RE: NCC2019 Volume One Amendment 1 | Section J Energy Efficiency Part J1 Statement of Compliance

SUBJECT PREMISE: Mixed Use Community Centre | 28 Fisher Road & 9 Francis Street, Dee Why NSW 2099

JHA
MARKUP / SKETCH

DOCUMENT No.: 200320 - 28 Fisher Road Dee Why
DOCUMENT TITLE: NCC 2019 Section J Building Fabric Requirements
DOCUMENT REV: RevA
DOCUMENT BY: LY DATE: 20/08/2020

DRAWING NO. **4089/1.3** AMENDMENT **DA**

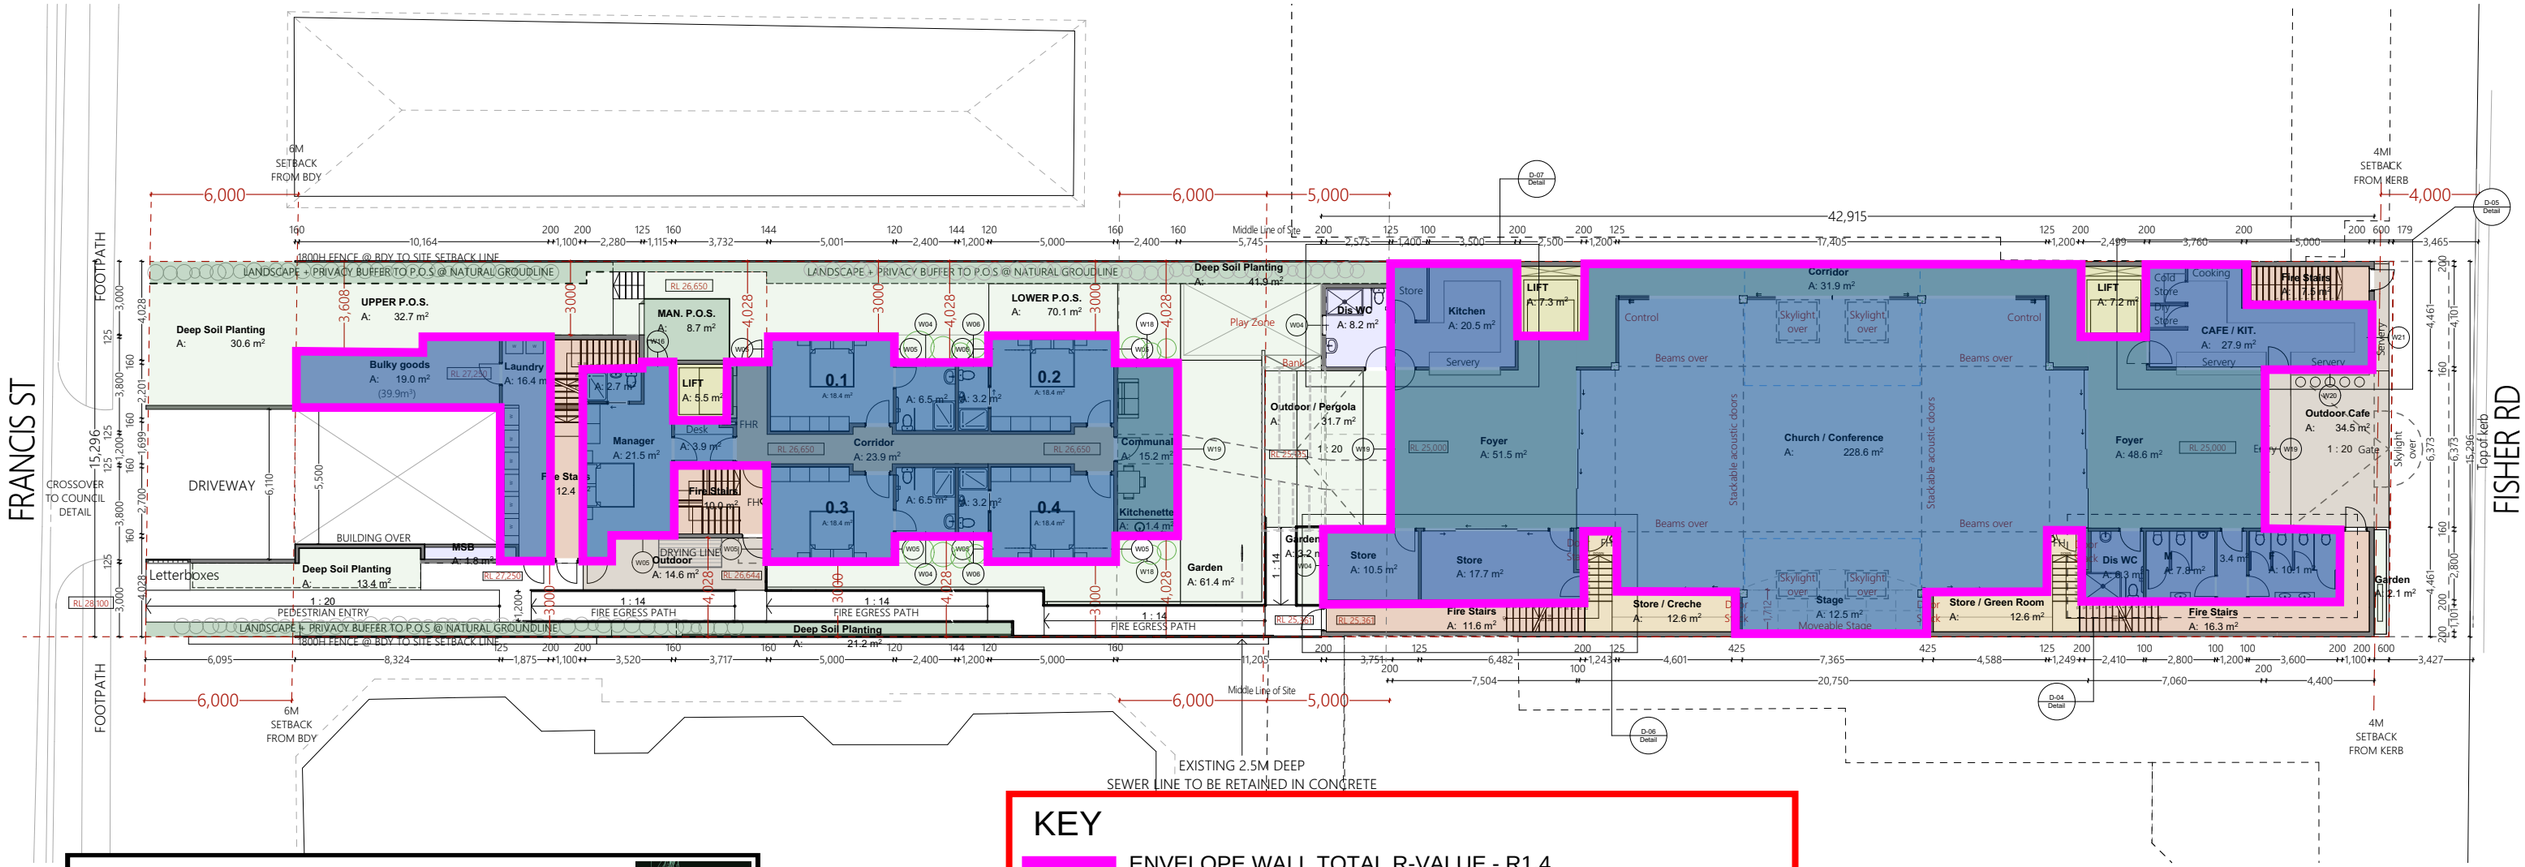
ENVELOPE WALL TOTAL R-VALUE - R1.4

ROOF TOTAL R-VALUE - R3.7 (Downward, SA < 0.45)

FLOOR TOTAL R-VALUE - R2.0 (Downward)

Notes:
1. It is a total system performance value and NOT the insulation.
2. The impact of Thermal Bridging must be included in the total system R-value calculations.
3. Roof Solar Absorptance (SA) must be no more than 0.45 (lighter colour)

DRAWING NO. **4089/1.4**
AMENDMENT **DA**

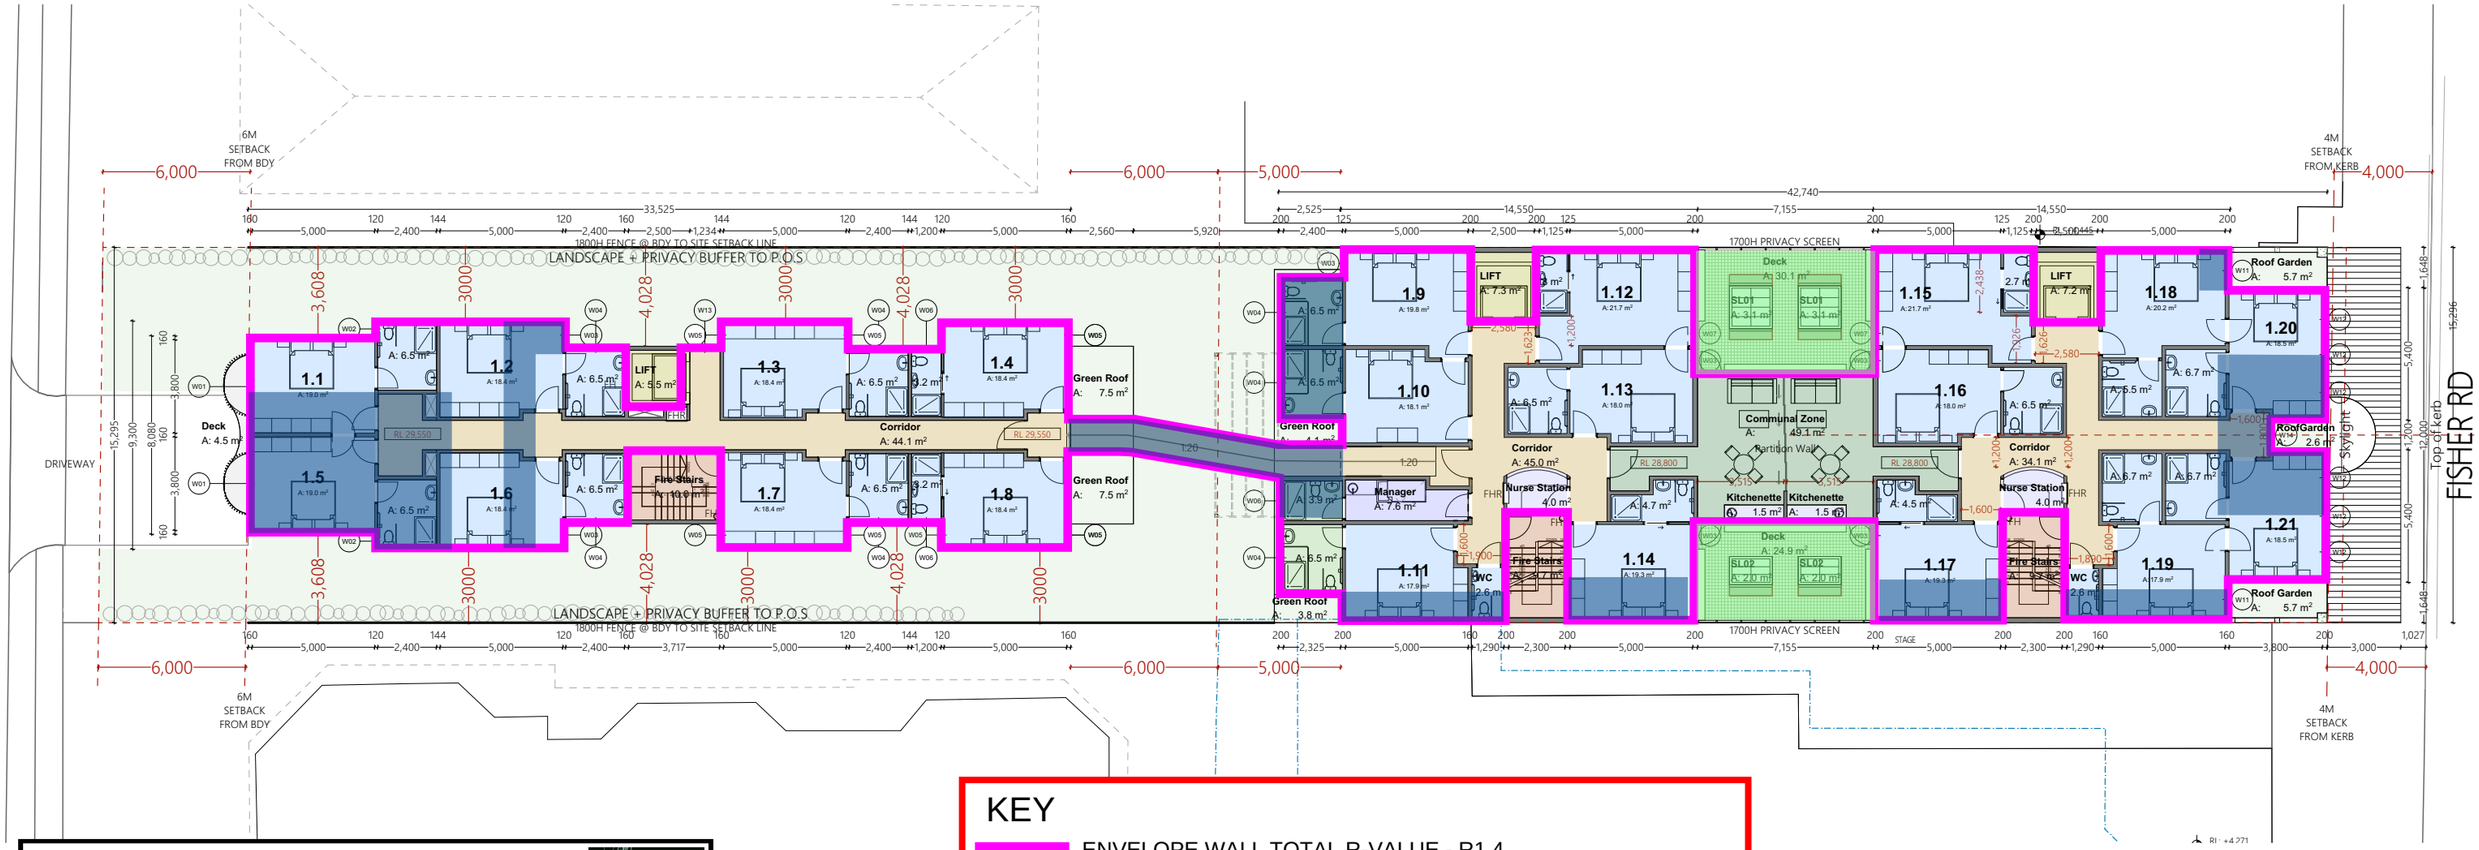
ENVELOPE WALL TOTAL R-VALUE - R1.4

ROOF TOTAL R-VALUE - R3.7 (Downward, SA < 0.45)

FLOOR TOTAL R-VALUE - R2.0 (Downward)

Notes:
1. It is a total system performance value and NOT the insulation.
2. The impact of Thermal Bridging must be included in the total system R-value calculations.
3. Roof Solar Absorptance (SA) must be no more than 0.45 (lighter colour)

DRAWING NO. **4089/1.5**
AMENDMENT **DA**

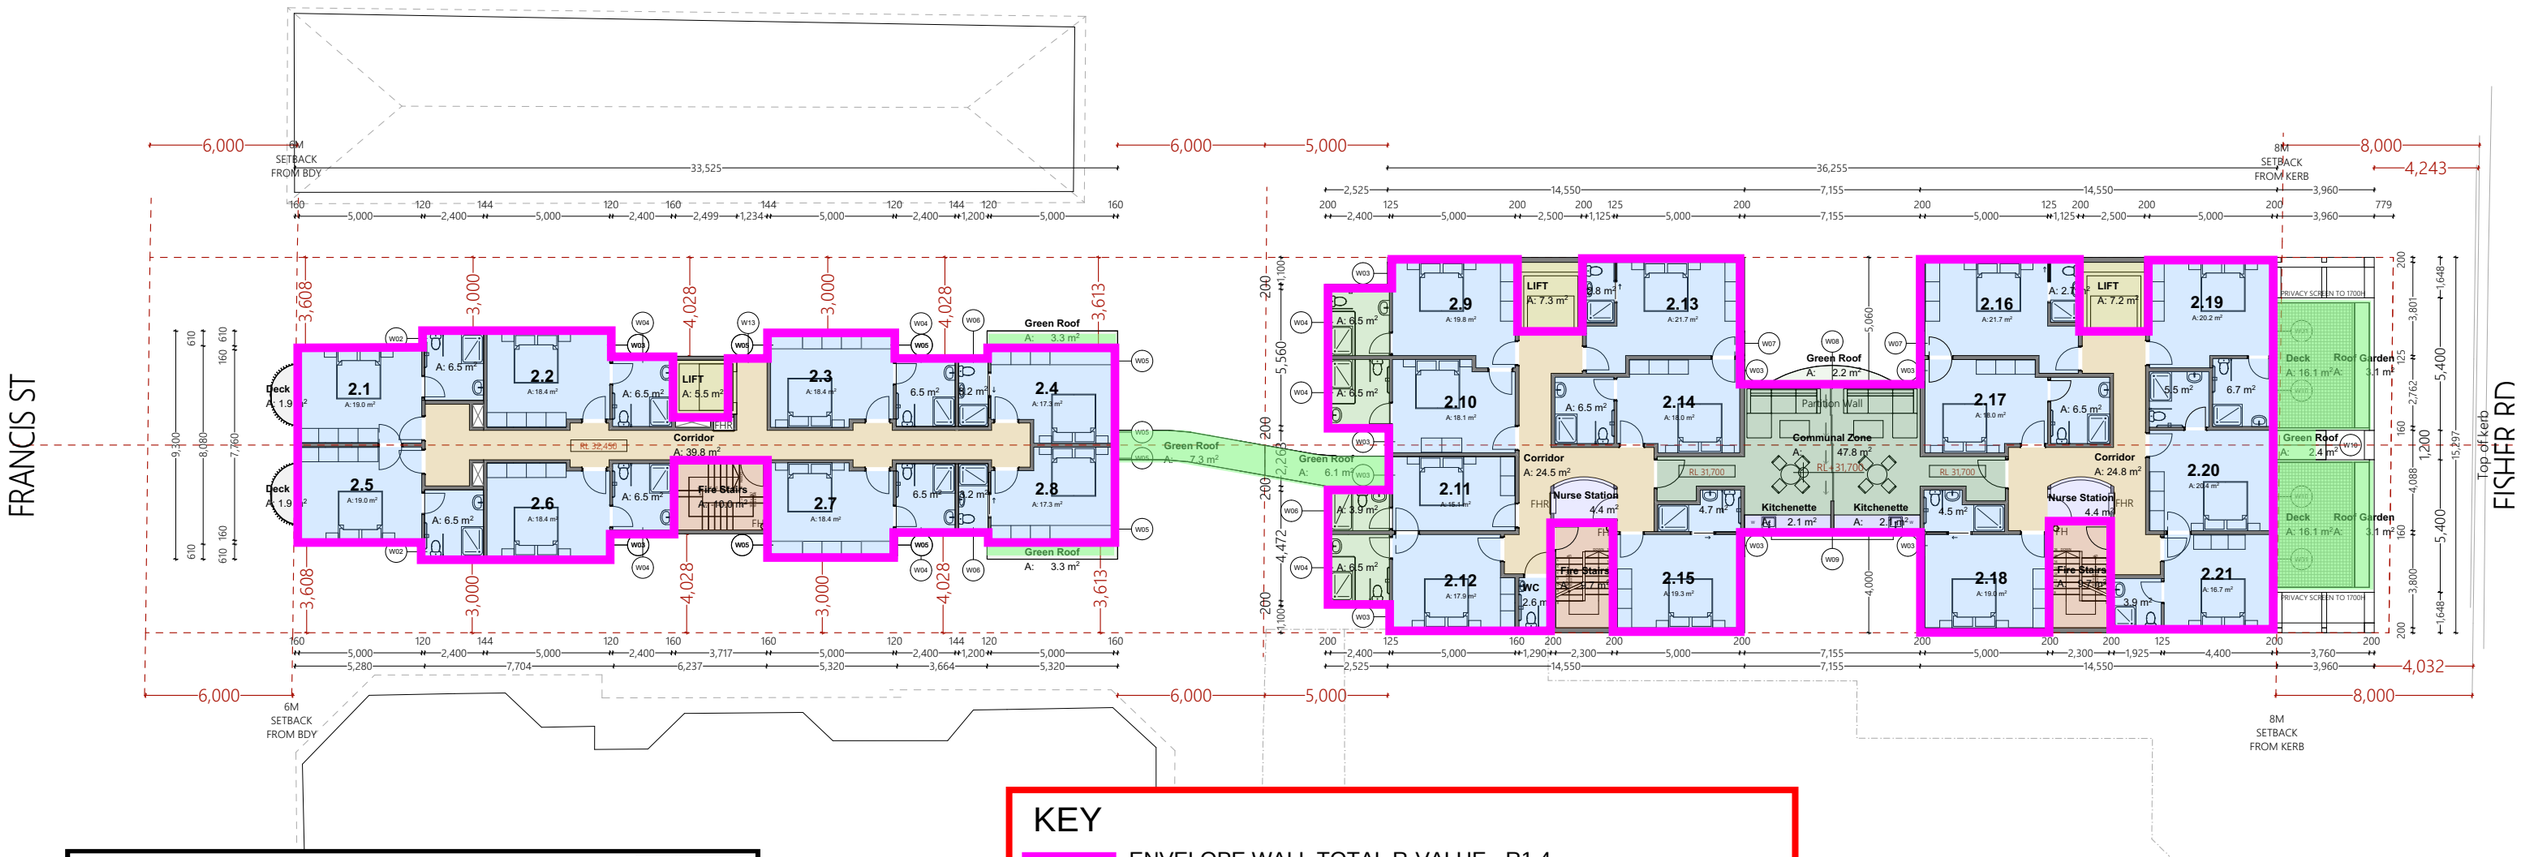
ENVELOPE WALL TOTAL R-VALUE - R1.4

ROOF TOTAL R-VALUE - R3.7 (Downward, SA < 0.45)

FLOOR TOTAL R-VALUE - R2.0 (Downward)

Notes:
1. It is a total system performance value and NOT the insulation.
2. The impact of Thermal Bridging must be included in the total system R-value calculations.
3. Roof Solar Absorptance (SA) must be no more than 0.45 (lighter colour)

DRAWING NO. **4089/1.6**
AMENDMENT **DA**

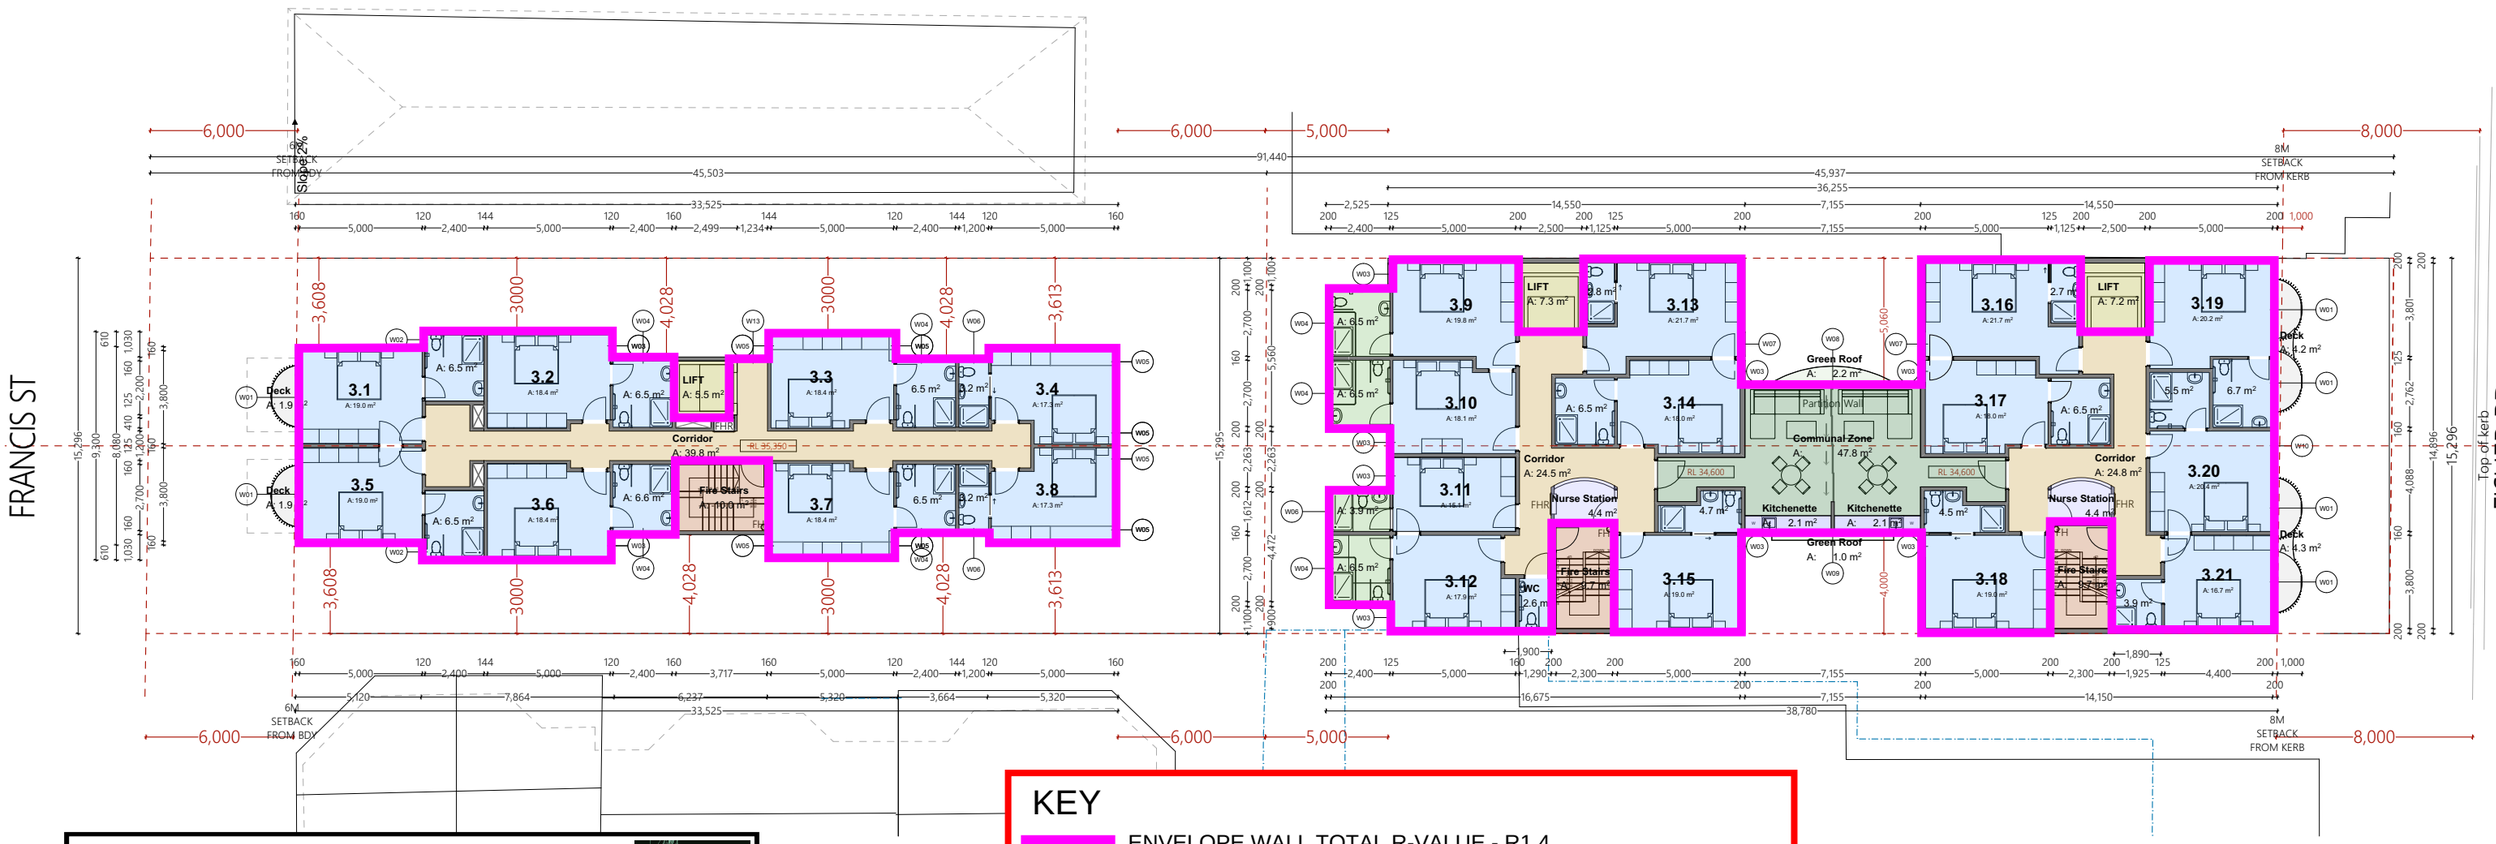
ENVELOPE WALL TOTAL R-VALUE - R1.4

ROOF TOTAL R-VALUE - R3.7 (Downward, SA < 0.45)

FLOOR TOTAL R-VALUE - R2.0 (Downward)

Notes:
1. It is a total system performance value and NOT the insulation.
2. The impact of Thermal Bridging must be included in the total system R-value calculations.
3. Roof Solar Absorptance (SA) must be no more than 0.45 (lighter colour)

DRAWING NO. **4089/1.7**
AMENDMENT **DA**

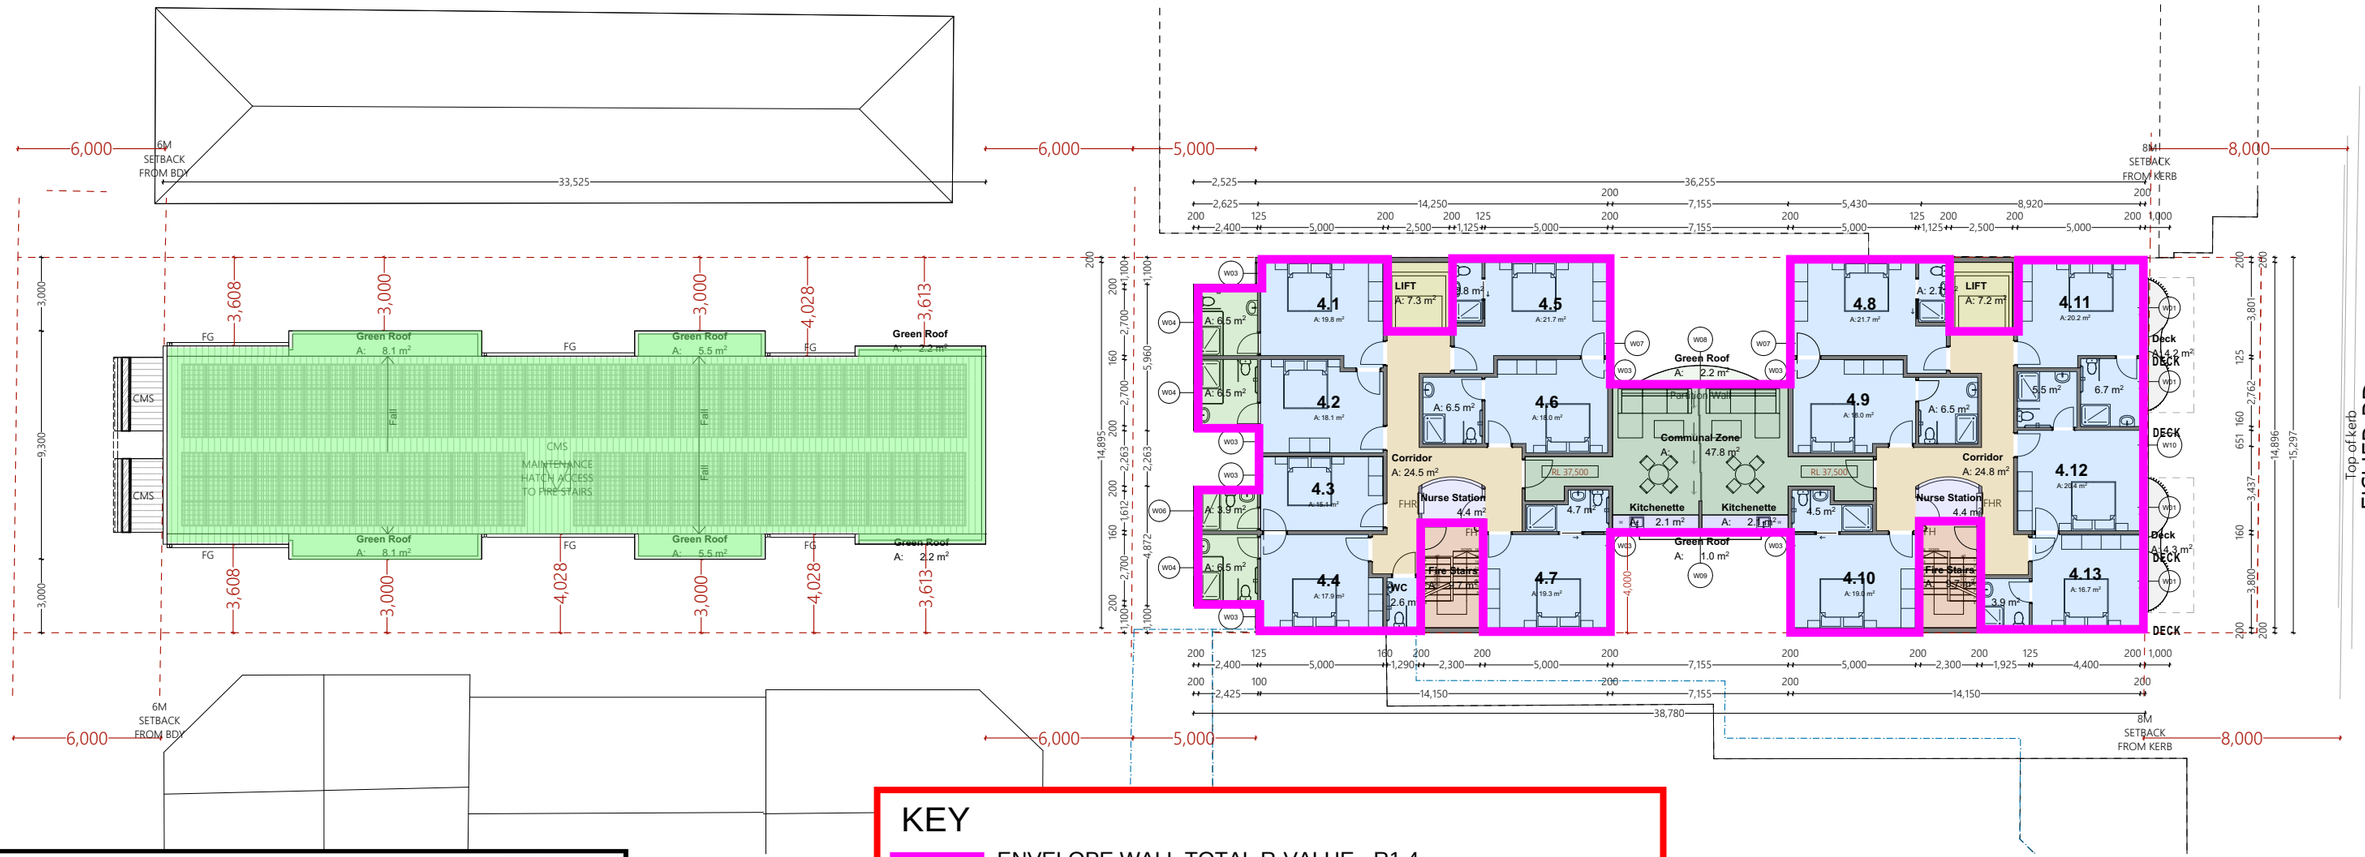
ENVELOPE WALL TOTAL R-VALUE - R1.4

ROOF TOTAL R-VALUE - R3.7 (Downward, SA < 0.45)

FLOOR TOTAL R-VALUE - R2.0 (Downward)

Notes:
1. It is a total system performance value and NOT the insulation.
2. The impact of Thermal Bridging must be included in the total system R-value calculations.
3. Roof Solar Absorptance (SA) must be no more than 0.45 (lighter colour)
